Beaver Valley Power Station, Unit No. 2  
Docket No. 50-412, License No. NPF-73  
Supplemental Information for Beaver Valley Power Station Unit 2 Spent Fuel Pool  
Rerack License Amendment Request (TAC No. ME1079)

February 28, 2011, March 9, 2011, and March 11, 2011  
Supplemental Information  
Page 1 of 5

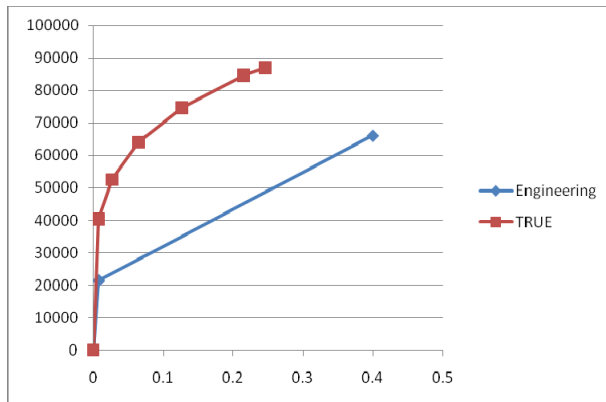
**2. Given that RAI 17 was focused on the evaluation performed for the shallow drop scenario, additional clarification regarding the use of stress-strain curve in the deep drop accident scenario is necessary.**

The engineering stress-strain curve was used to represent the welds for the deep drop accident. This curve is conservative for this application. A comparison was made between the engineering stress-strain curve used for the deep drop analysis versus the true stress-strain curve used for the shallow drop analysis. For the deep drop analysis (which used engineering stress-strain), the failure strain limit is input as 0.4. For the shallow drop analysis (which used true stress-strain), the failure strain limit is

input as 0.2465 for welds. The area under each curve represents the strain energy that can be absorbed prior to failure. A comparison of the curves is provided below. The strain energy determined from the engineering stress-strain curve is nearly equal to that of the true stress-strain curve, with the true-stress strain curve having slightly more capacity.

Strain Energy True - 17289 Lbf-in/in <sup>3</sup> Engr. - 17247 Lbf-in/in <sup>3</sup>
--

For the deep drop event, the limiting component is the cell-to-baseplate weld. The strength of the cell-to-baseplate welds is the determining factor for the deep drop event. Since the strain energy associated with the engineering stress-strain curve is almost identical with that of the true stress-strain curve, the length of cell-to-baseplate welds that plastically deform up to the failure limit would be the same as the current solution.

Subsequently, the limiting deep drop analysis (scenario 1) was reperformed using the true stress-strain curves for both the weld and the base material from the shallow drop analysis. The failure strain limits are also the same as those used in the shallow drop analysis. The material properties are defined in Section 7.4, "Mathematical Model," of the Licensing Report. The peak baseplate vertical deflection remains the same as shown in Figure 7.5.3 (that is, 1.837 inches). In other words, the results are consistent with the strain energy comparison between the true stress-strain curve and the engineering stress-strain curve. Although the above evaluation supports the use of the engineering stress-strain curve, the updated analysis utilizing the true stress-strain curves will be used as the licensing basis.
